THE NORTHERN BEACHES HOSPITAL (STAGE 2)

SUBMISSIONS / PREFERRED INFRASTRUCTURE REPORT

PROJECT REFERENCE: SSI 6792

9 April 2015

Figure 11: BICYCLE PARKING
(4.02.15)

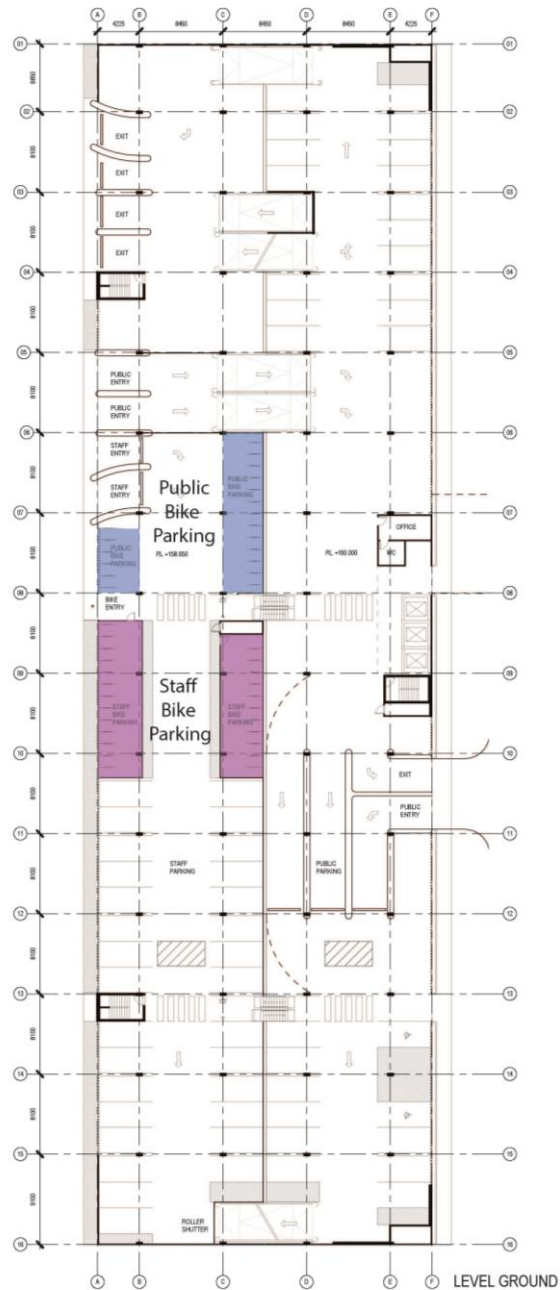
6. It is not clear where bicycle parking will be placed in the parking garage. TfNSW supports provision of bicycle racks to be located in secure, convenient, accessible areas close to the main hospital entries incorporating adequate lighting and passive surveillance, close to end of trip facilities. TfNSW requests the Proponent clarify this issue in the response to submissions.	Provision for both staff and public bicycle parking has been made at ground level within the carpark structure (refer Figure 11).
Facilities for pedestrians and cyclists are to be provided in accordance with the required standards and to align with those being proposed by Roads and Maritime as part of the Connectivity and Network Enhancement Project and Warringah Council's pedestrian and bicycle plan.	The CaNE EIS notes that as part of Stage 1 (CaNE EIS, Section 5.2.2, Naree Road and Frenchs Forest Road West, page 52, SMEC, October 2014): <i>"A 1.5 metre concrete path would be provided on the northern side of Naree Road and Frenchs Forest Road West within a 3.5 metre footpath reservation. A verge would be provided, and would vary between one to two metres in width depending on topography"; and</i> <i>"A 3.5 metre concrete path would be provided within the footpath reservation on the southern side of Naree Road and Frenchs Forest Road West."</i>
